**Planned Unit Development – Lot 3 Southport East
Replat Six; 8040 Eastport Parkway – Hausmann
Holdings, LLC**

**CITY OF LA VISTA
PLANNING DIVISION
RECOMMENDATION REPORT**

CASE NUMBERS: PPUD24-0001;

RE: Hausmann Construction Office Building Planned Unit Development
Initial Review Letter

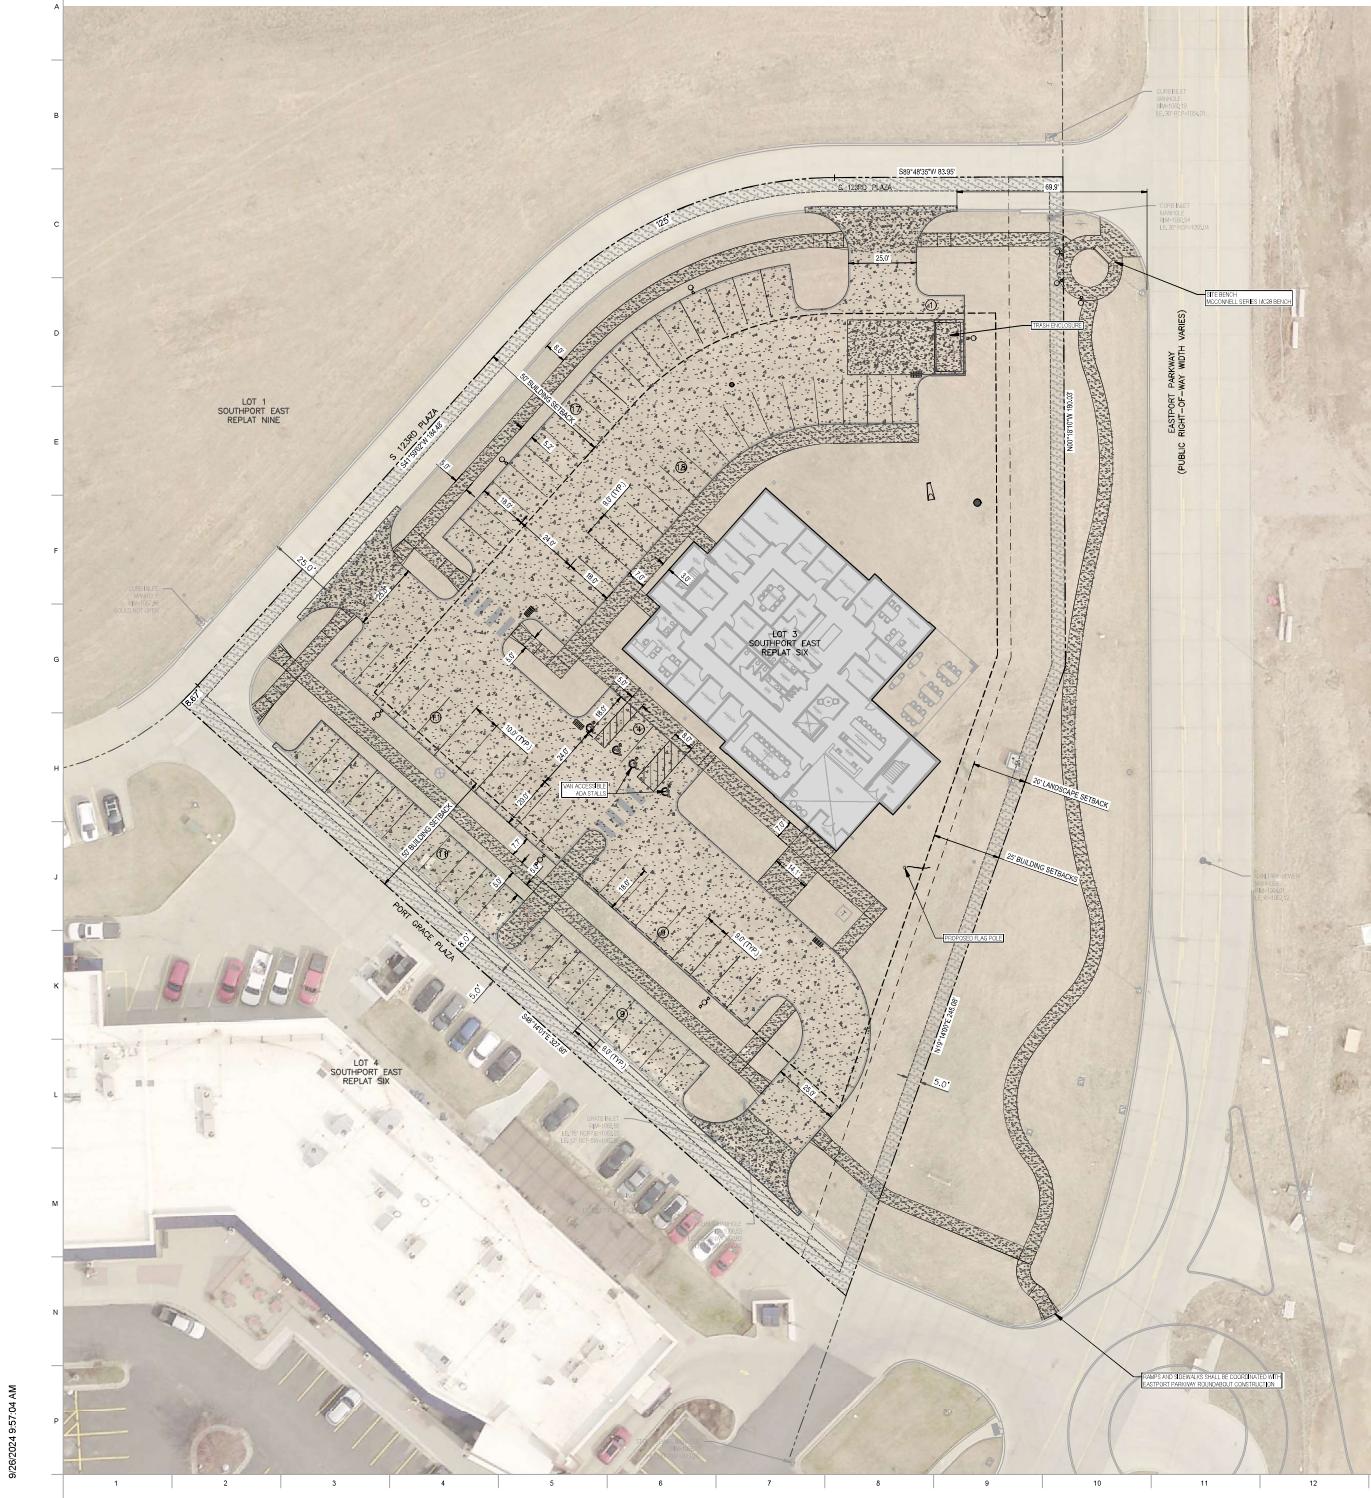
14. Please include a sidewalk ramp for the sidewalk on the west edge of the property that directs toward Lot 1 Southport East Replat 9, and confirm that the alignment does not conflict with the storm sewer inlet on the other side of the street, as noted in the attached redline site plan.

Response: A ramp directed towards Lot 1 Southport East Replat 9 has been added. The alignment does not conflict with the storm sewer inlet on the other side of the street.

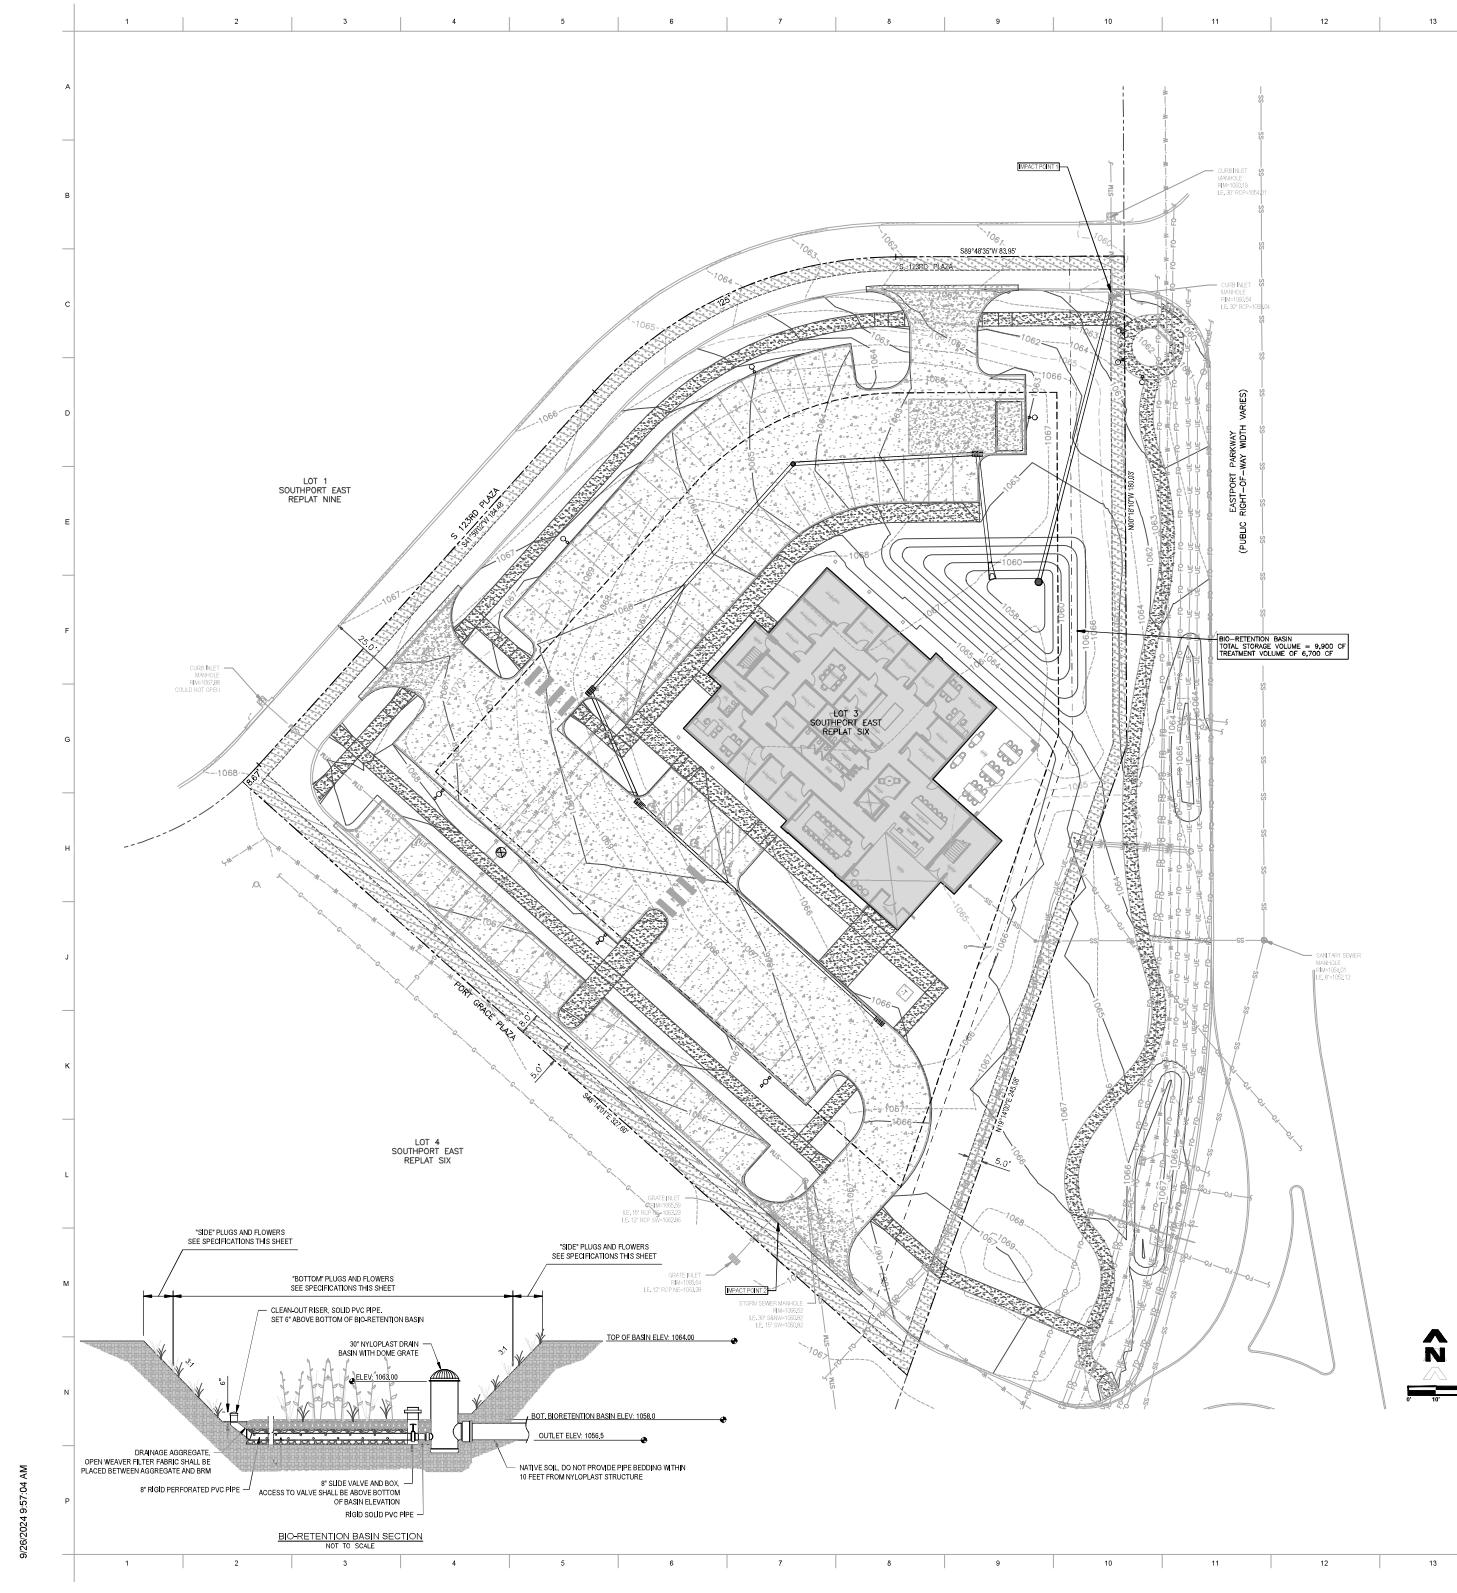
5. Per Section 5.15.05.04, please include the calculations for the pre and post development 100 year events on the Post Construction Stormwater Management Plan Sheet (Sheet 5 of 6).

Response: The 100 year event has been added to the table.

TRASH ENCLOSURE

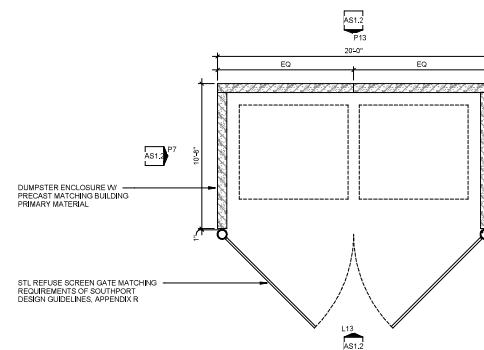
13. We recommend relocating the dumpster enclosure to the northeast corner of the property to move it further from the travelway edge and the entrance of the building, as noted in the attached redline site plan. Please confirm the waster hauler truck routing and turning movements are acceptable to properly service the trash enclosure.

Response: Dumpster enclosure has been relocated to the northeast corner of the property.
